CT90K5

COMPARISON OF CT90K5 TO CT90K4

Fig. K5.1 ① Brake panel ② Arrow
③ Reference mark ④ Brake

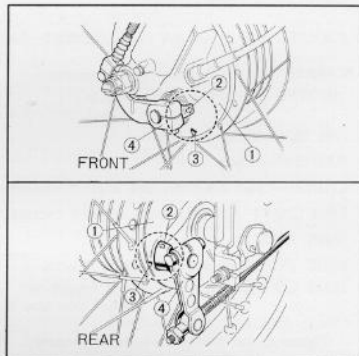
On the CT90K5, new wear indicators were provided in the front and rear brakes. When the brake applied, an arrow, adjacent to the brake arm, moves toward a reference mark on the brake panel. The distance between the arrow and the reference mark, on full application of the brake, indicates brake lining thickness.
